TO: DEVELOPMENT REVIEW BOARD DATE: November 20, 2003

SUBJECT: CASE 48-DR-2003

REQUEST: Approve site plan & elevations for public parking garage

PROJECT NAME: 2nd and Brown Parking Garage

#2-Context Aerial #2A-Aerial Close-Up #3-Zoning Map #4-Site Plan

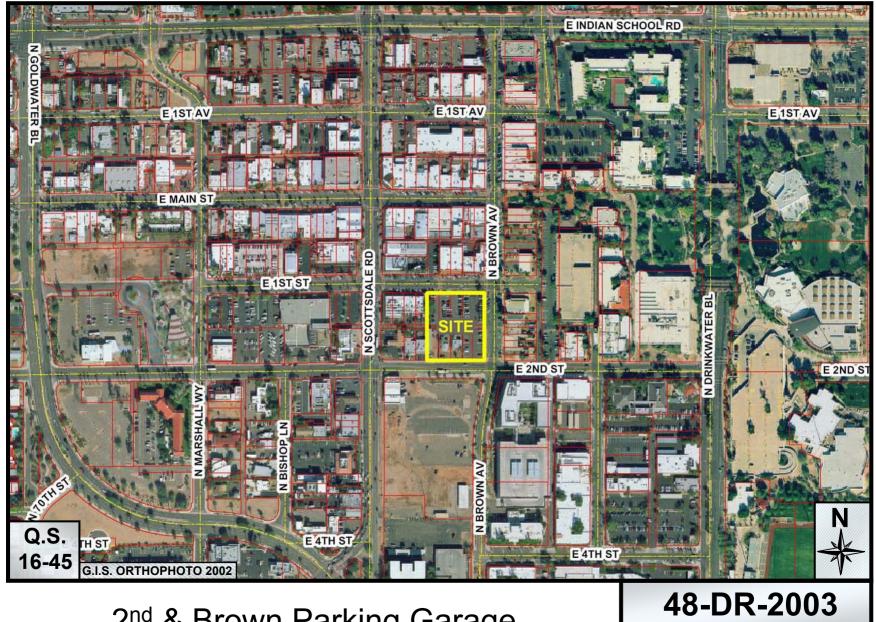
Pedestrian access at Brown – The site plan shows no sidewalk along the entrance drives at Brown Avenue. A minimum width 4-foot sidewalk will be provided.

- 3. A four-foot wide sidewalk shall be provided along the side of the driveways at Brown Avenue.
- 4. The plans shall be revised to incorporate the commemorative plaza at the southwest corner of the site.

PRELIMINARY SITE PLAN

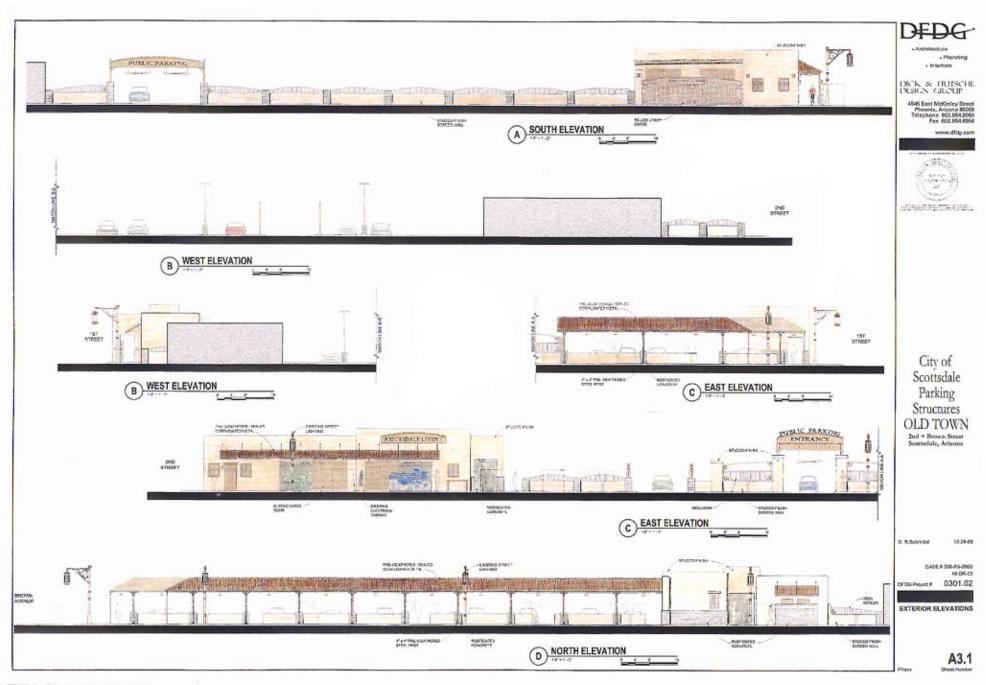
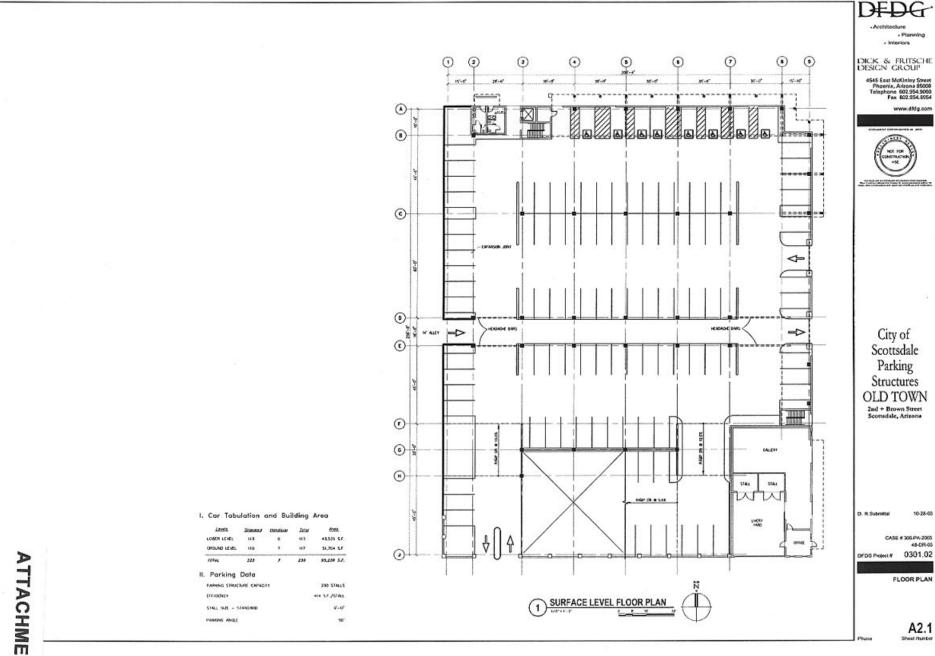
Entrance on Brown – The entrance at Brown is flanked by large columns that appear to be heavy in relationship to the ranch entry feature above the driveway. Therefore the column features will be revised in scale to more closely match the scale of the columns at the entry feature on 2^{nd} Street.

Noriega Plaza – The Noriega family previously used the houses located along the south side of the site and there is a community desire to provide commemoration. Therefore the site will be revised to include space for a plaque, bench and plaza at the southwest corner entrance to the parking lot.

- 5. The mass of the entry columns located on Brown Avenue shall be decreased to more closely match the column widths of the entry on 2nd Street.
- 6. The face of the service entrance section(s) shall be flush with the building façade and painted to match the building.
